### Response to Submissions

Eliwana Iron Ore Mine, EPA Assessment 2125.

EW-RP-EN-0003.001\_2

**Figure 1: Groundwater Drawdown and Groundwater  
Dependent Vegetation (maximum drawdown)**

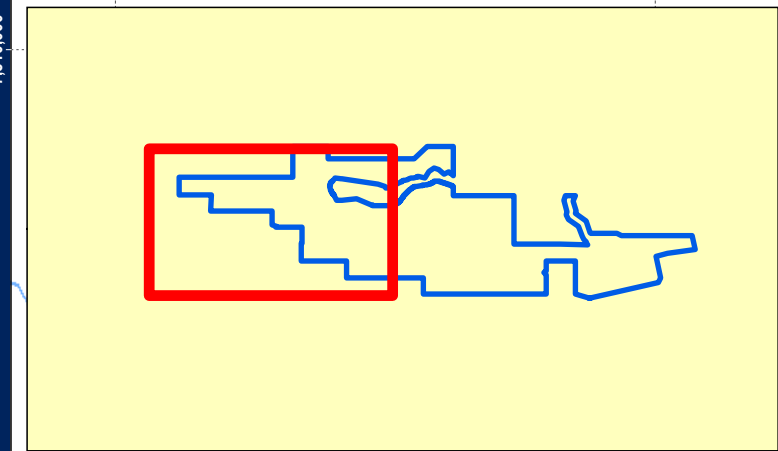
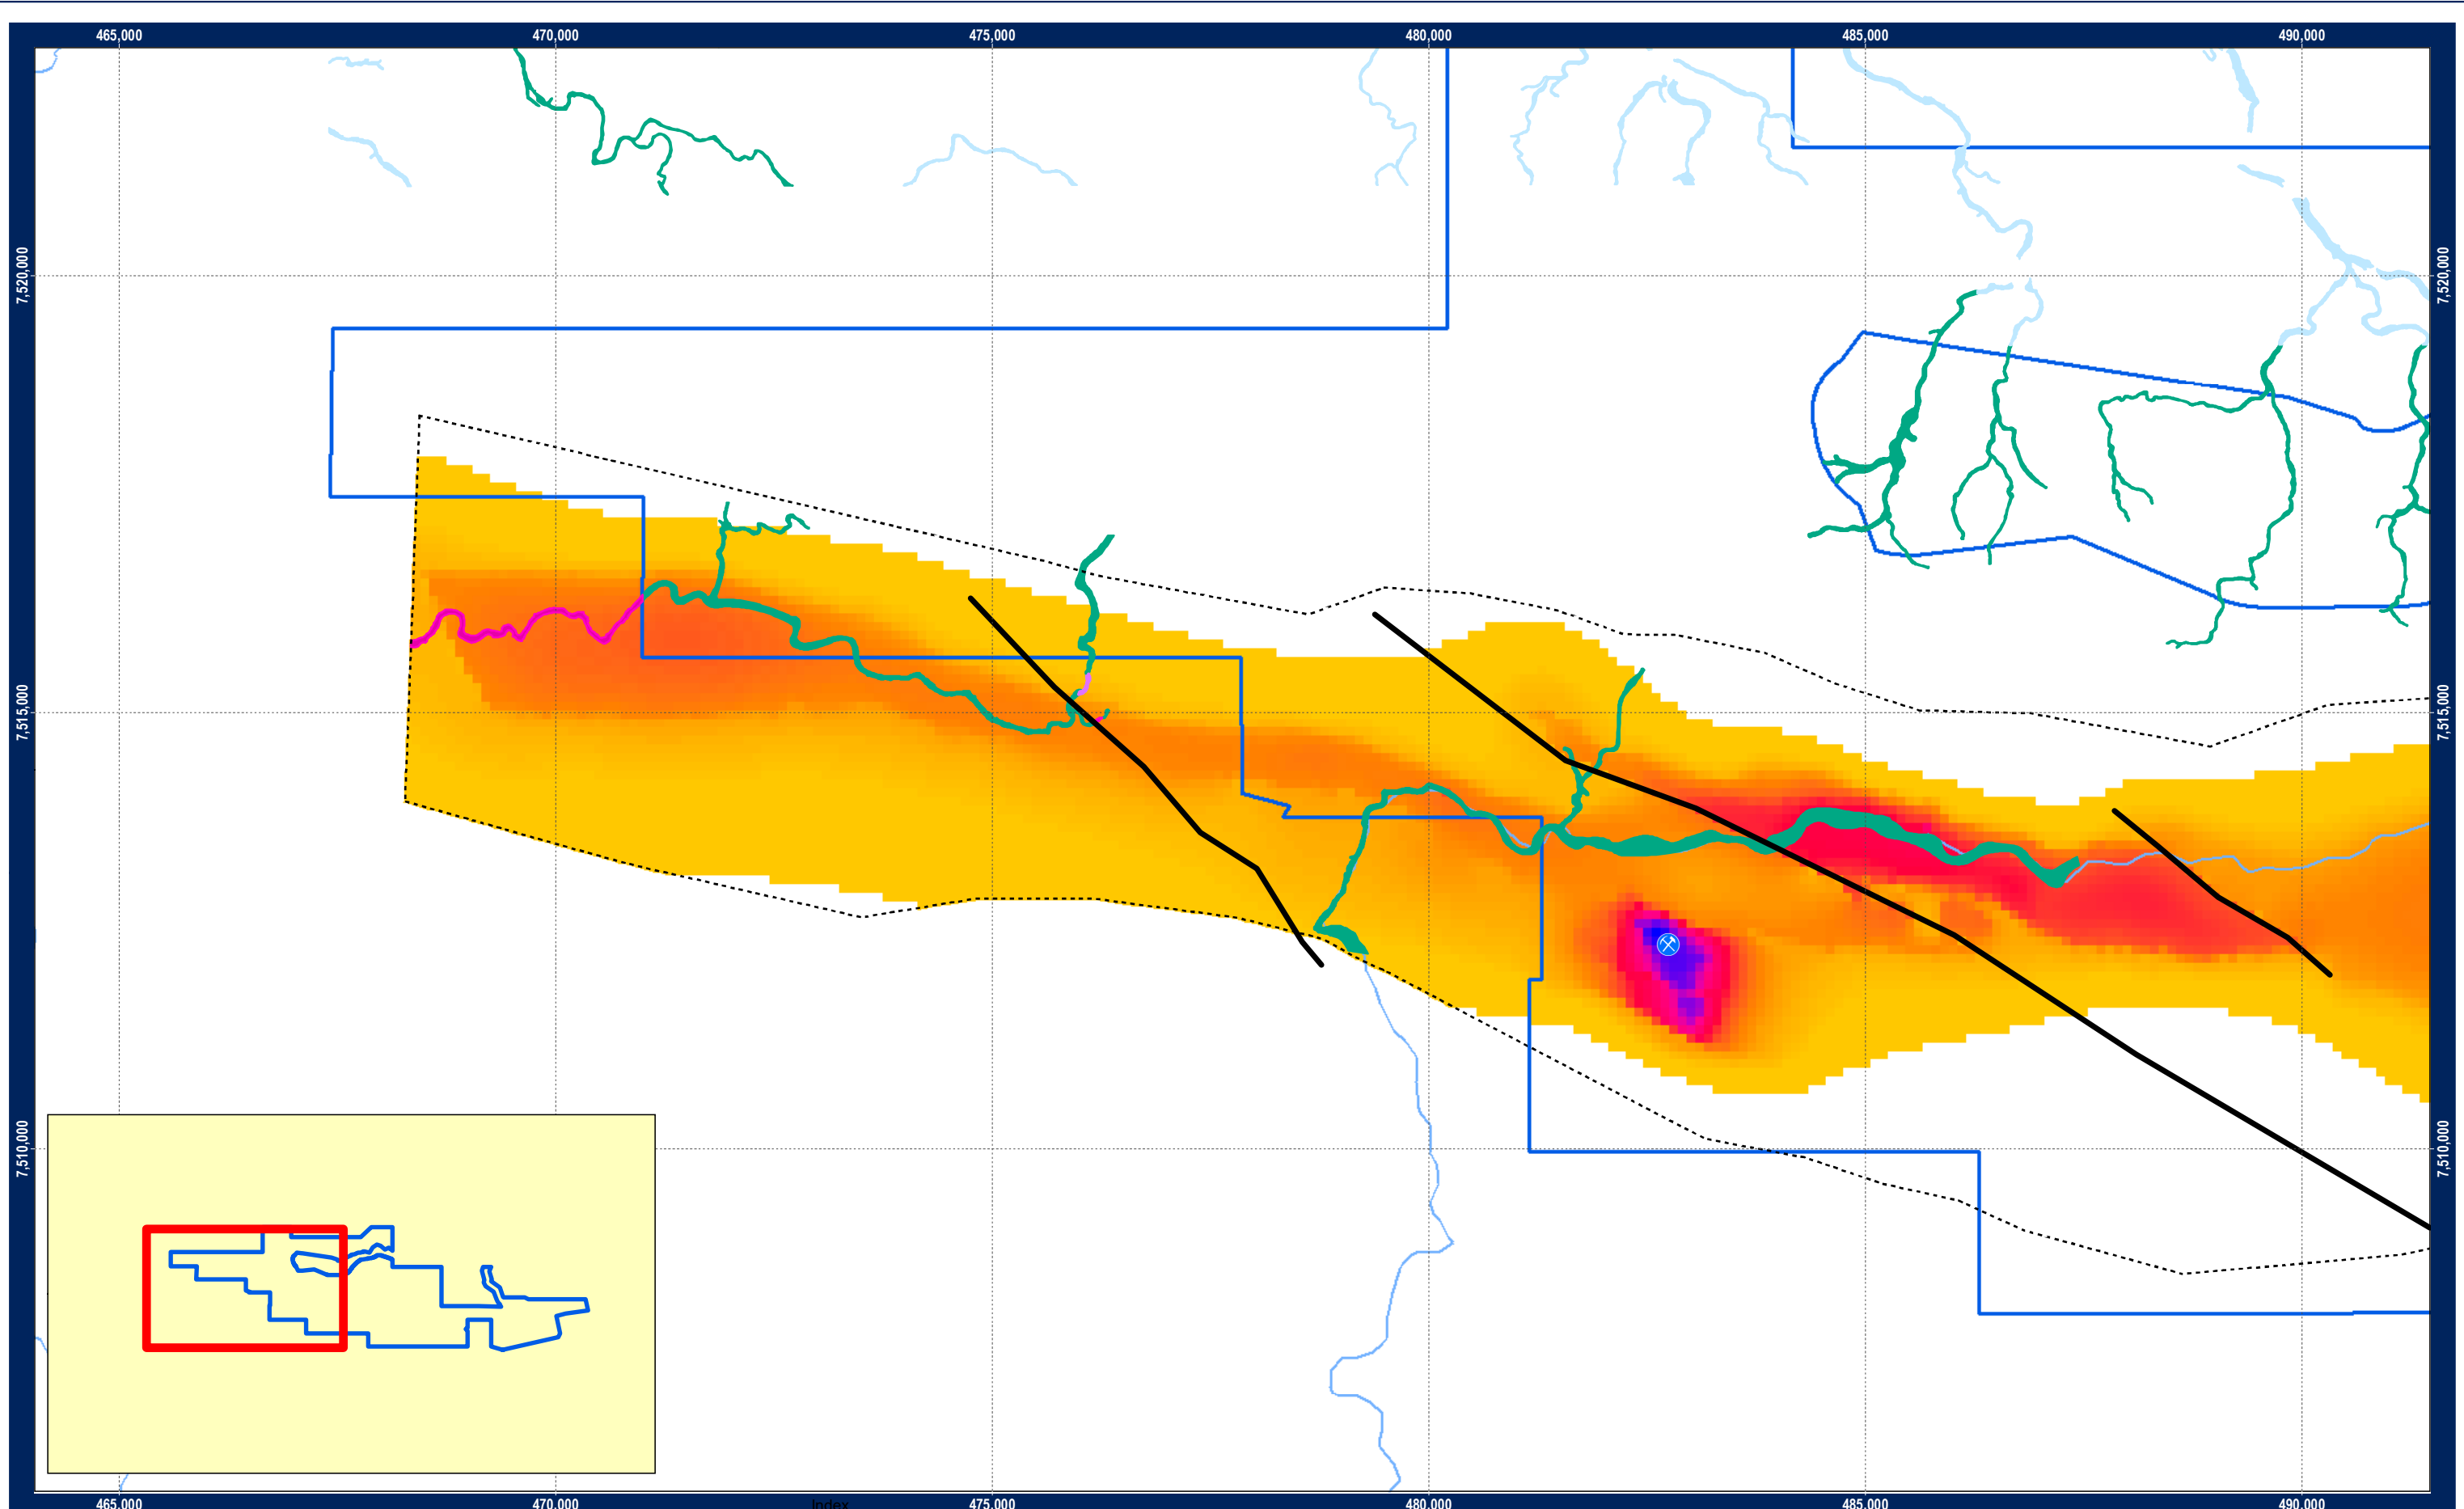
No.	Commentator	Comment	Response
		<p>EvAcCcERlt and EvAcMgERlt) and describe the likely levels/ types of dependencies.</p> <p>Although areas of GDV are shown in Figure 19 (Section 4.6.4.7, p199), the community types are not specified, nor is there any indication of depth to groundwater nor predicted drawdown/ change. It is therefore not possible to access the impacts described in section 4.6.5.10 and Table 30.</p> <p>As it is unclear from the current figures provided, the EPAS requests an additional figure with labelled GDV vegetation communities (eg. EcAcEuaTe) and also potential GDV communities, relative to labelled contours of the ground water drawdown for maximum drawdown and the expected residual drawdown post mining.</p>	<p>Figure 26 (Maps 1 – 3) overlay these vegetation communities onto the predicted maximum groundwater drawdown. This figure, and the assessment in Table 30 provides the information the respondent seeks to determine the impacts of groundwater drawdown on GDE or potential GDE vegetation.</p> <p>Fortescue acknowledge that Figure 26 does not differentiate between the various GDE and PGDE vegetation communities, however, each community is discussed in Table 30. Figure 26 has been amended to differentiate between each community (Figure 1 of this document) and a further figure has been prepared which shows the extent of residual drawdown 100 years after cessation of groundwater abstraction (Figure 2 of this Document). This residual drawdown is discussed further at Item 46.</p>
